# REGIONAL REVIEW FINDING

**ARC REVIEW CODE:** R1303151

**Name of Proposal:** 100 Northpark

**SUBJECT:** **Transportation Division Review of DRI # 2334**

STATE	PROJECT NUMBER	SHEET NO.	TOTAL
GA.	NH-056-1(52)	30	77

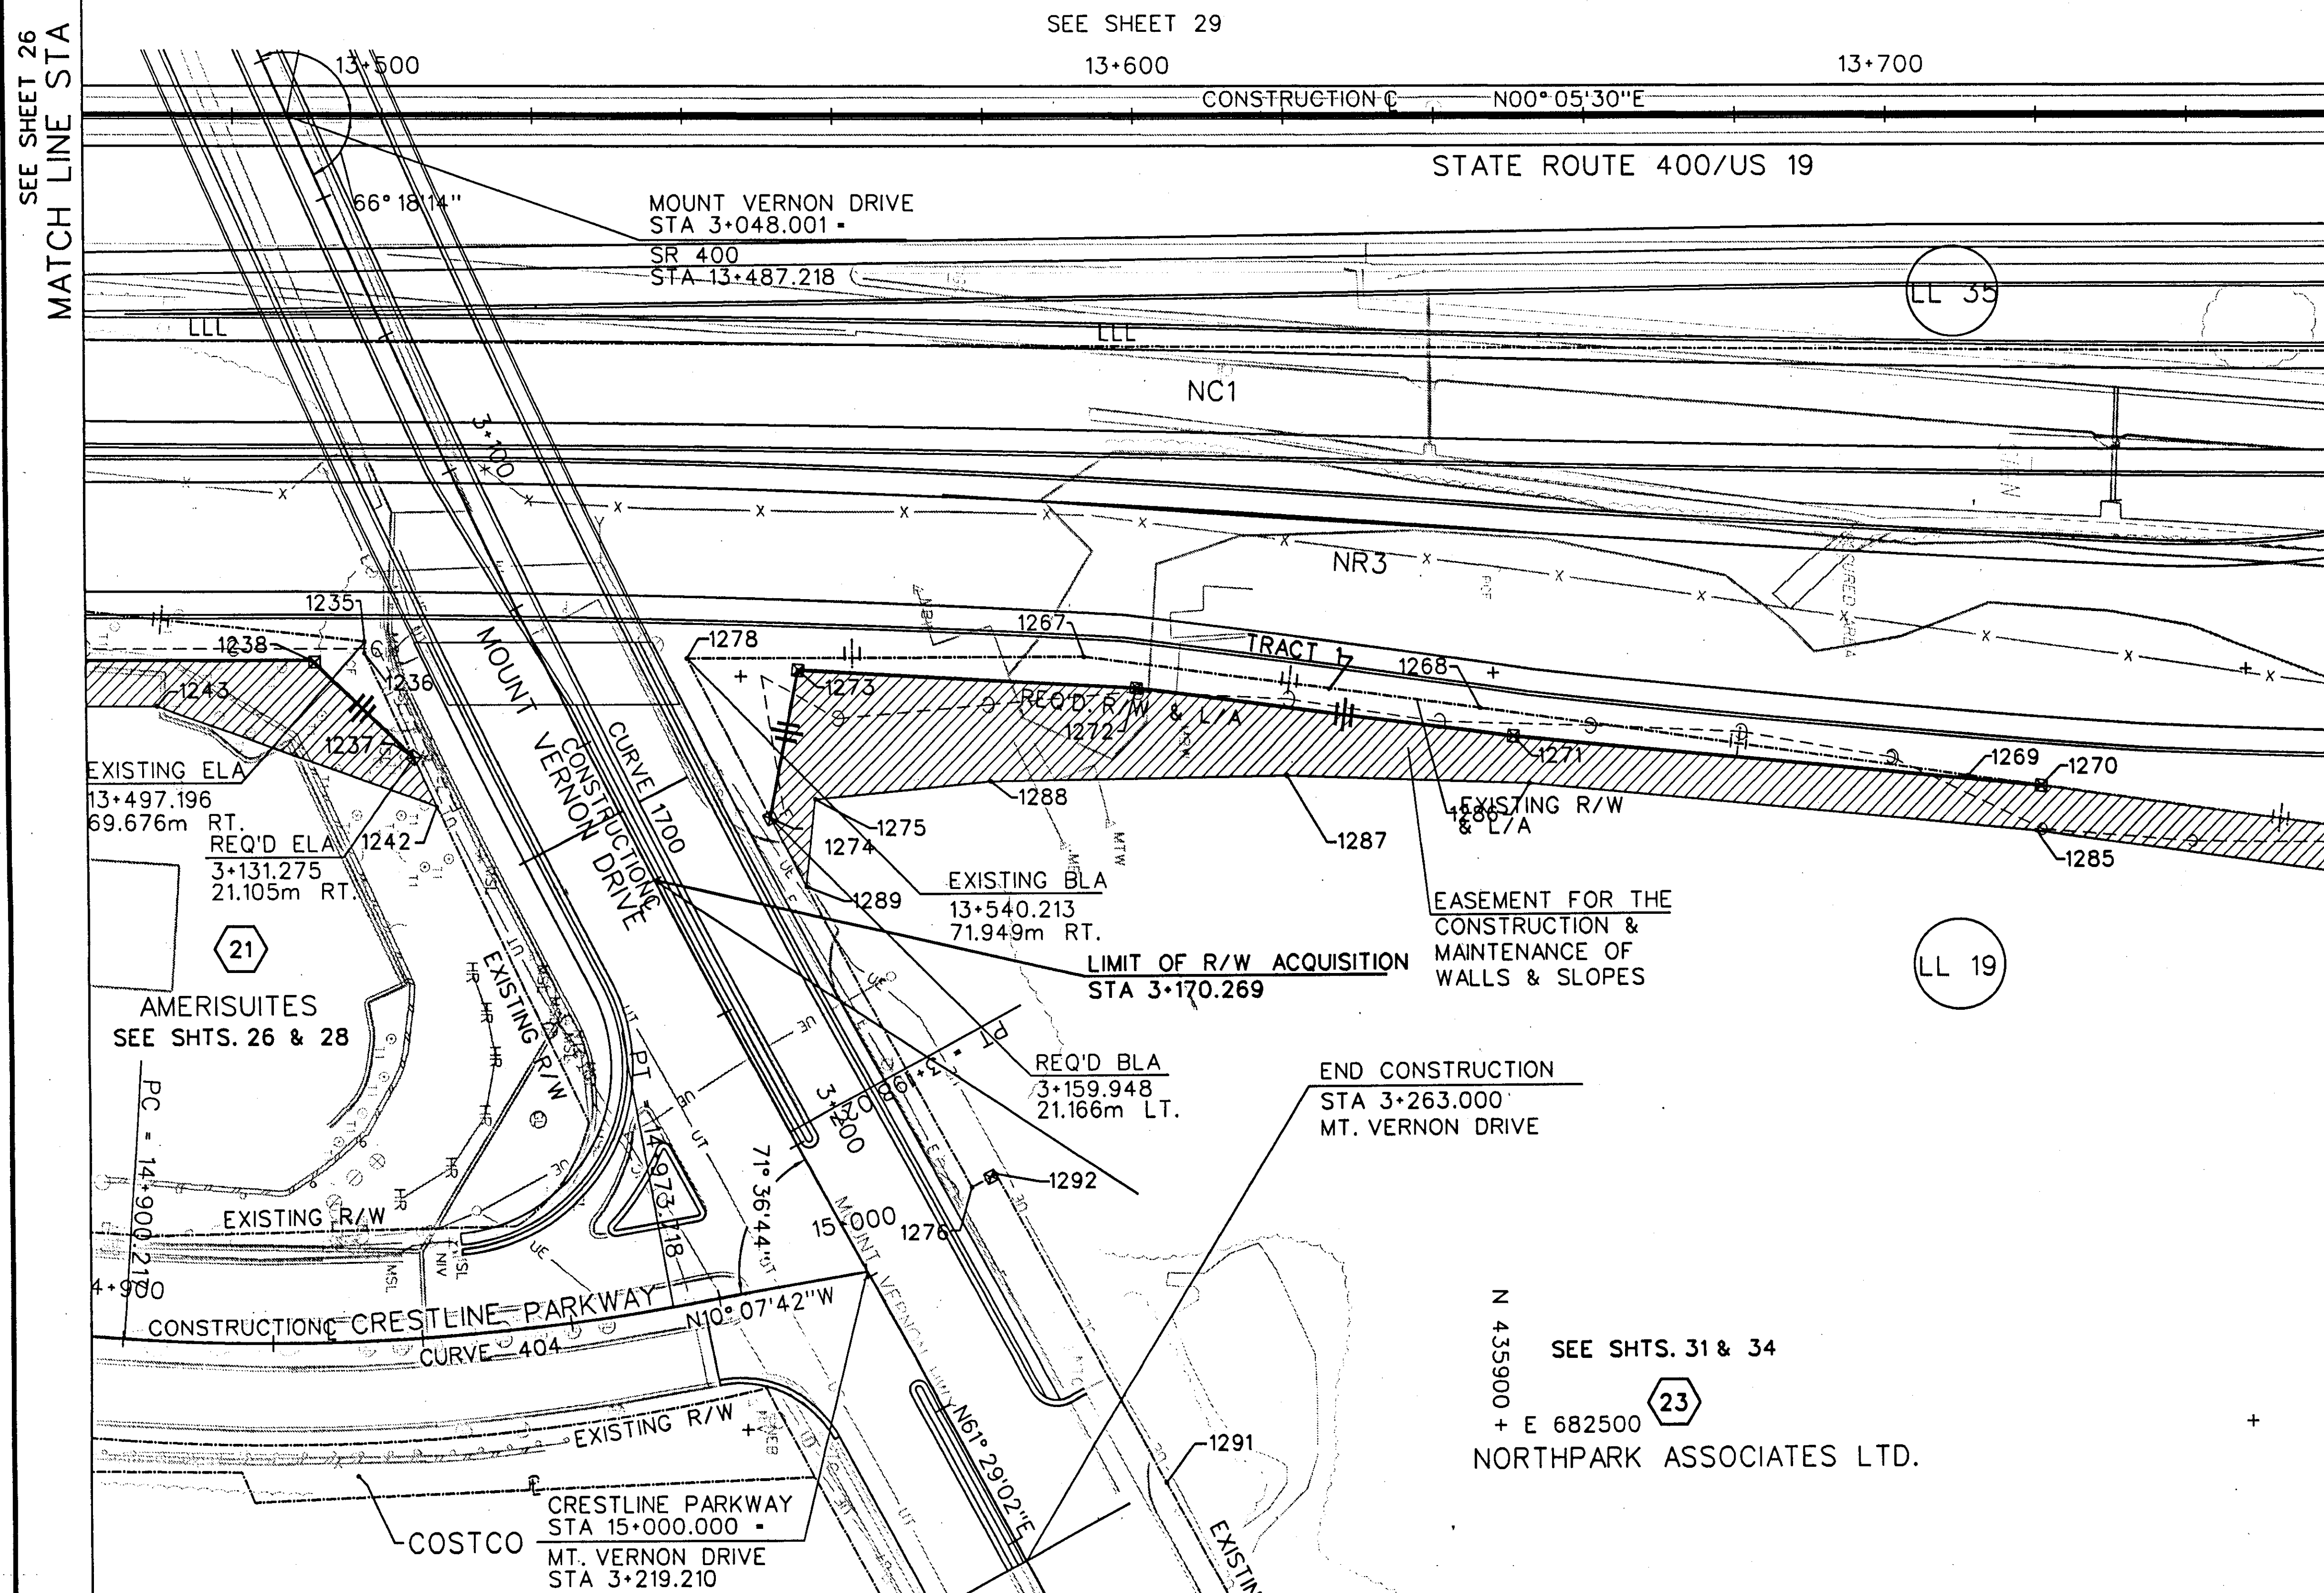
Please see the attached file which shows the proposed SR 400 CD project overlaid on the DRI development. There are a couple of major issues/inconsistencies to point out that should be explored further before proceeding, in my opinion.

- The existing ROW along SR 400 that is shown in both the DRI and in Fulton County GIS appears different than the existing ROW shown in the SR 400 CD project. The DRI shows about an extra 60' strip of property along SR 400. The CD project's identification of existing right of way is shown in dashed blue in the attached file. It appears that the property limits match for this property along 3 of the 4 sides, but not along SR 400. It should be noted that the existing L/A fence may or may not follow the actual existing ROW.

- The proposed DRI does not appear to have been designed to reflect the RW or easement needs from the approved R/W plans for the SR 400 CD project. The required RW from those plans is shown in solid red (for illustration only) and the easements are in solid orange in the attached file. If what this overlay shows is correct, there will be significant impacts to the retail areas, one of the proposed office buildings, and to driveway #3, based on the GDOT Acquisition.

Since the CD project has an approved environmental document and approved right of way plans, these issues should be looked into immediately. The parcel is identified as Parcel 23 (ROW Sheet Attached) on the ROW plans for the CD project (PI 721850). This parcel has not been acquired as of this date, according to my research.

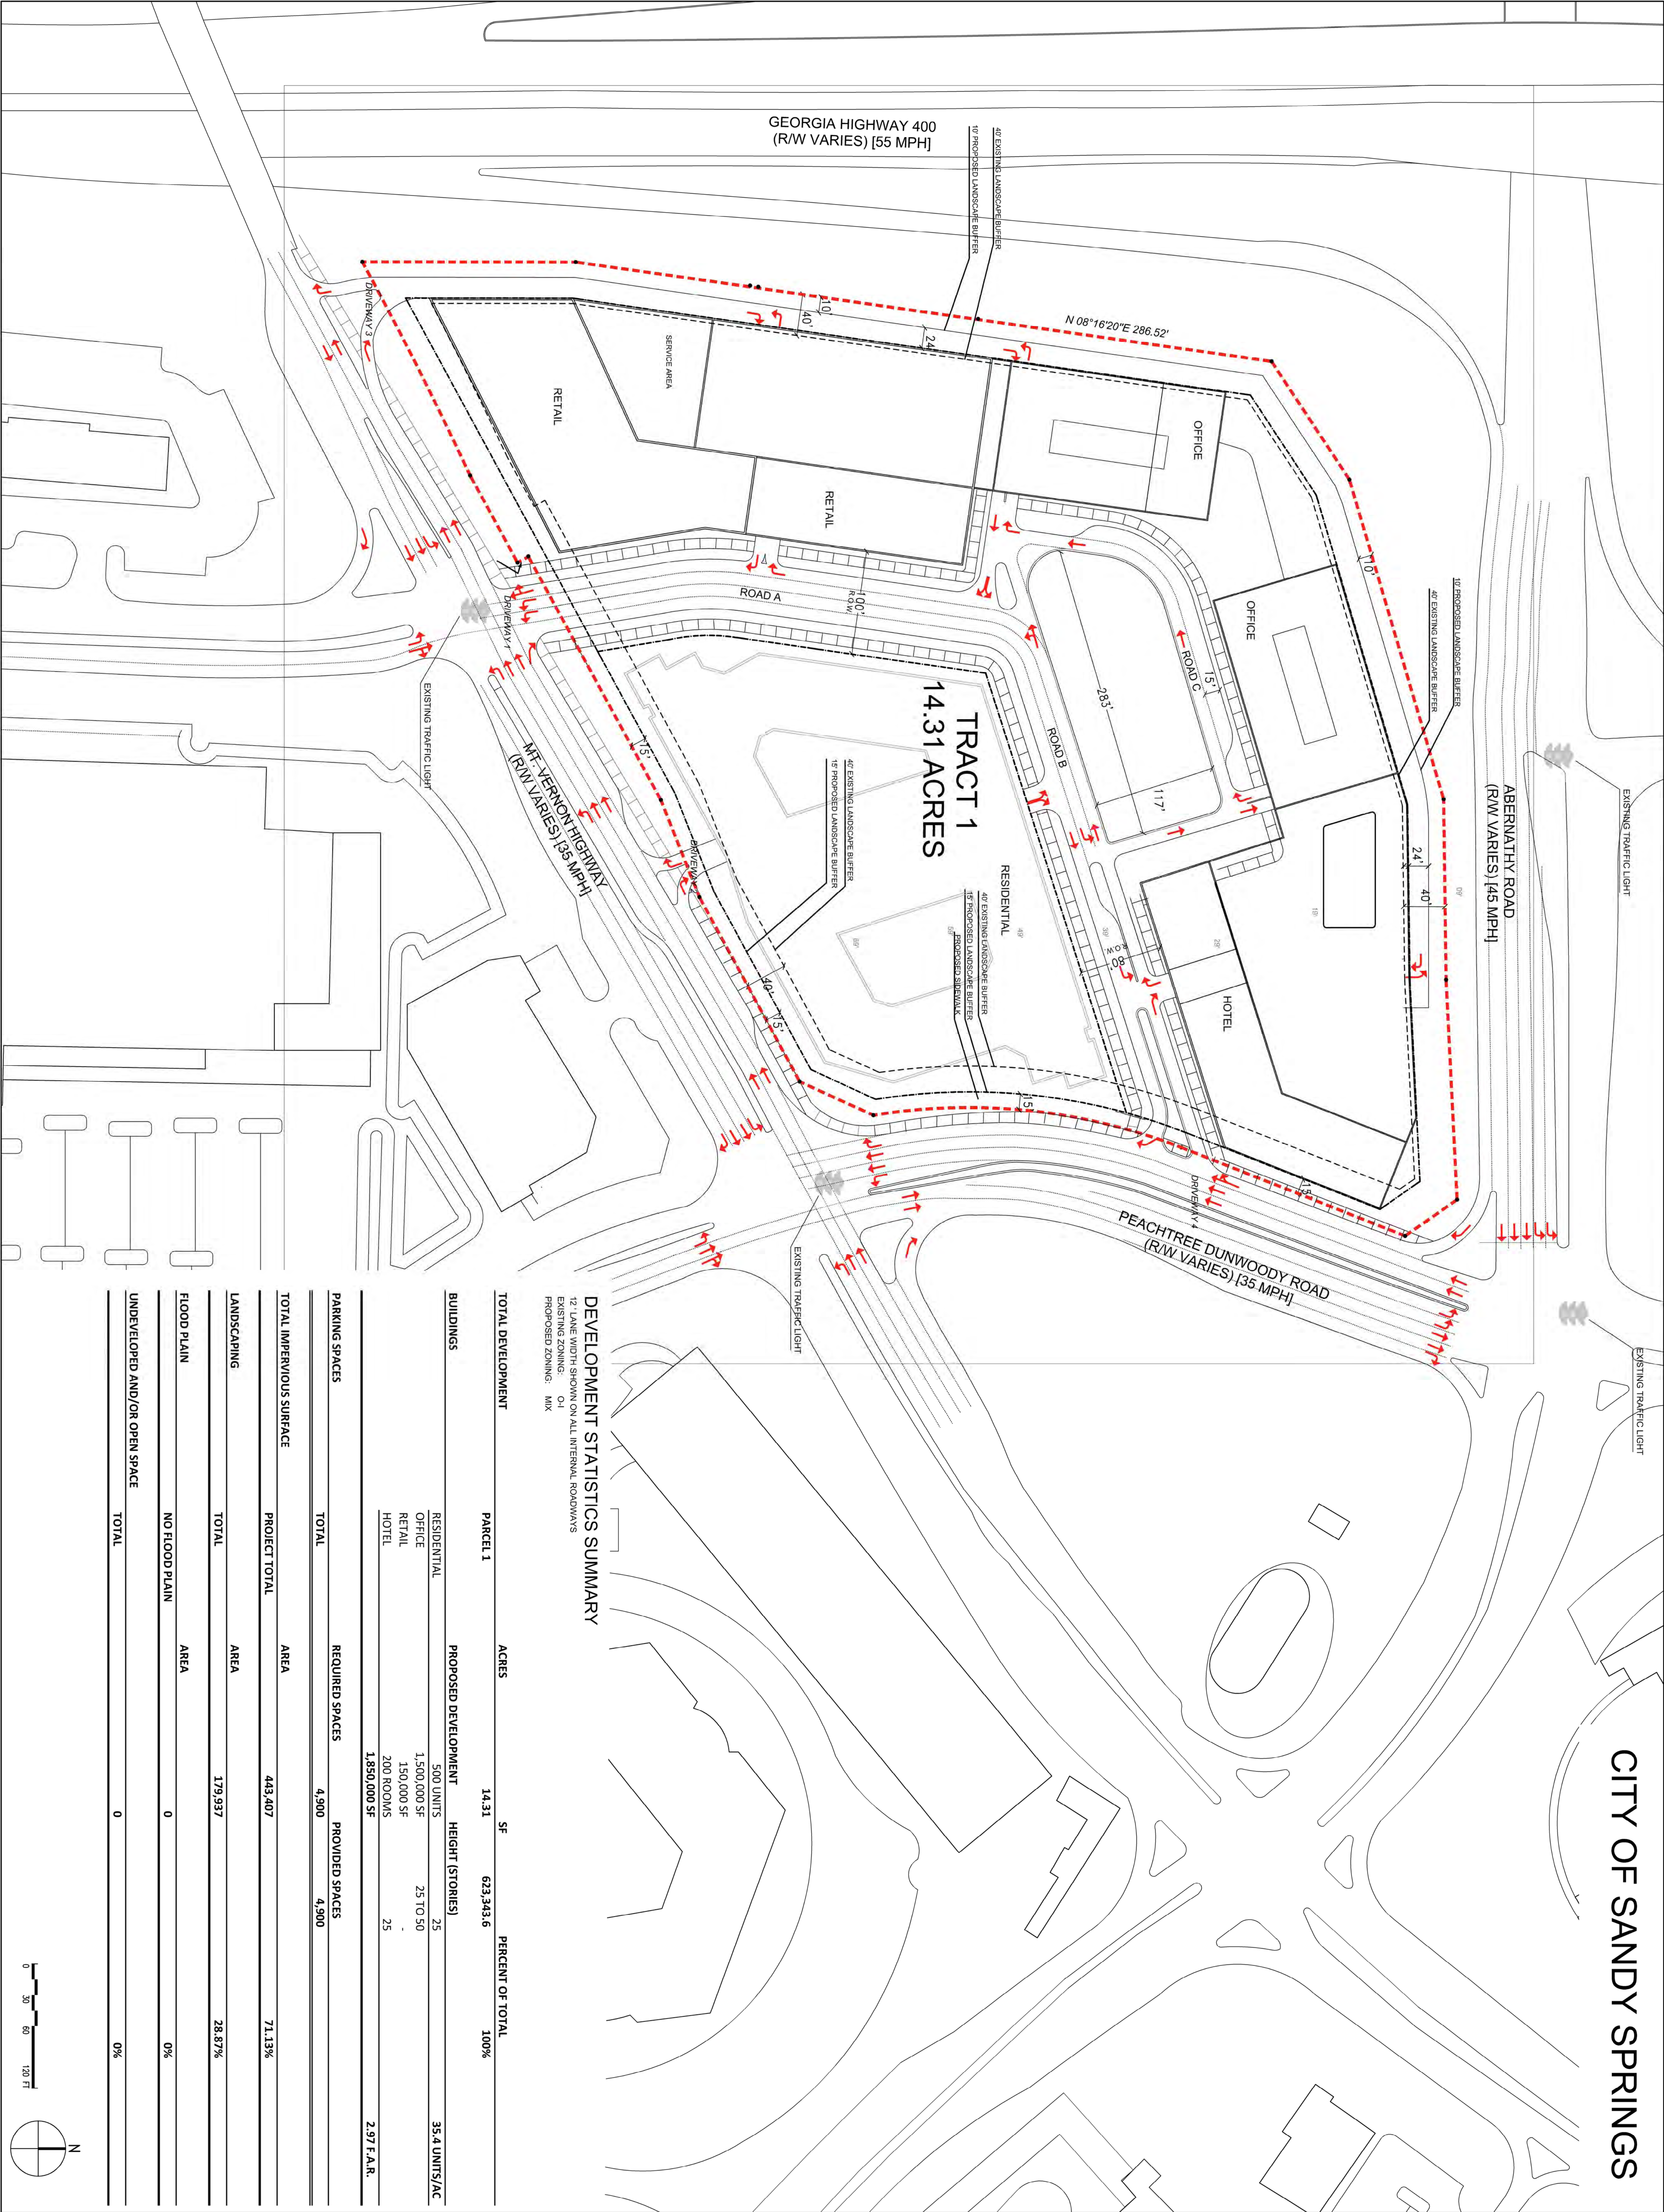
ARC stated that this DRI is going through an "expedited review" and could you take a look at the attached layout (last page of the first document) and see/guess how close it is to the CD and ML projects and send them any more detailed comments (if warranted) by this Friday? Russell was in the meeting with us and ARC and suggested we send this along to you, since Marlo is still out sick.
